Historic Landmarks and Preservation Districts Commission

Report to the Committee

Case No: 21-COA-0025
Classification: Committee Review

Property Address: 318 S. Ewing Ave.

Original Proposal

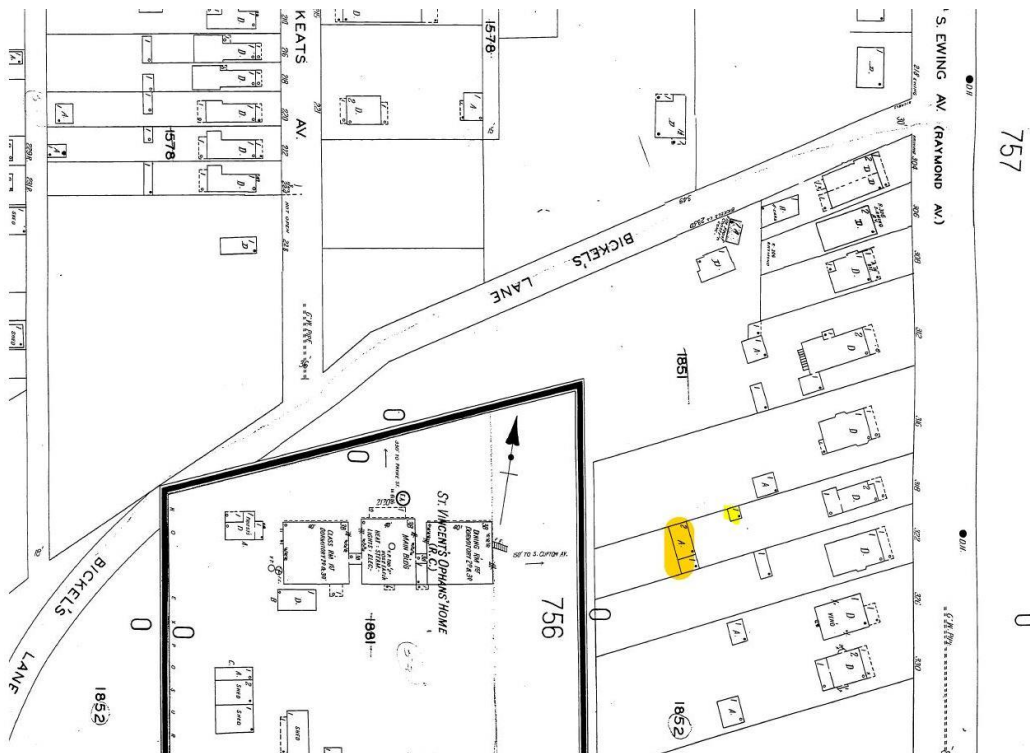
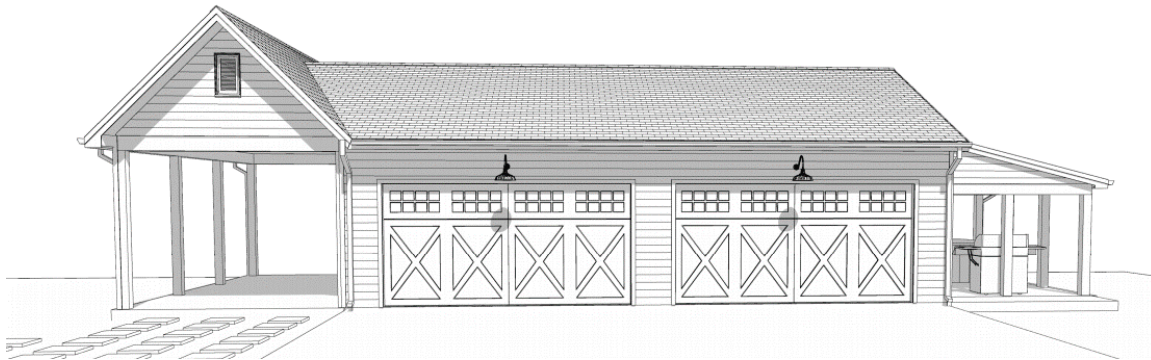
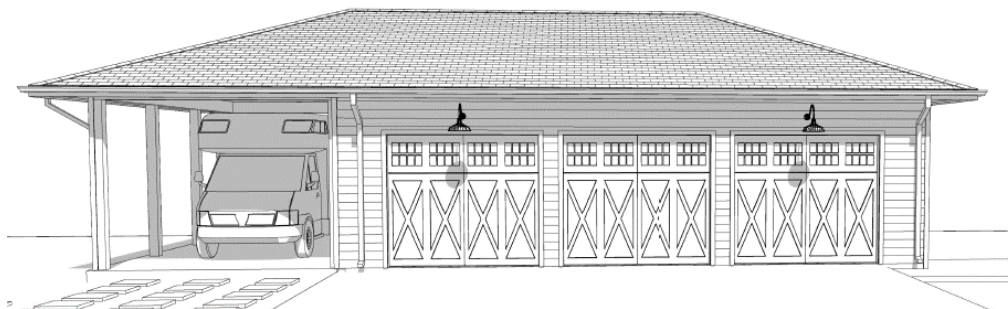
(Note: Applicant responded to staff and ARC recommendations in the updated proposal in terms of removing the front porch and a garage bay, reducing the depth, reducing the roof massing and height, and changing from double garage doors to single. Findings for the updated proposal are substantially similar to the prior report with the exception of the design now meeting more of the guidelines for Garage. The building is still somewhat larger than directly adjacent secondary structures, but is more in line with larger ones on the street and in the neighborhood.)

The proposal generally meets the requirements set forth by the Clifton design guidelines. The overall scale and massing were the most divergent guideline issues in the original proposal, but this has been better addressed in the new drawings with shortening the width, depth and height, removing the street facing porch, and making the roof a continuous hip style which reduces the massing considerably. Clifton does have a mix of secondary structure sizes, and the height and materials are complementary to surrounding structures. These are particularly long lots compared to most within Clifton and are backed by a 65' drop to the rear east yard rather than other homes. The garage will be sited mostly behind the garage located at 316 S. Ewing so will be less visible from the street than the existing outbuilding. The open portions of the carport help to break up the massing, and the orientation of a short side facing the street with a person door and window help tie it to the smaller homes and secondary structures along the street.

On the basis of the updated information furnished by the applicant, staff recommends the application for a Certificate of Appropriateness for the new construction be **approved with the following conditions:**

1. Staff shall be notified if archaeological discoveries such as artifacts, features, and other archaeological deposits are found during construction.
2. If CMU foundation is visible above grade, it shall be parged.
3. All other required permits and approvals shall be acquired prior to construction.
4. If the design or materials change, Staff shall be contacted for review and approval.
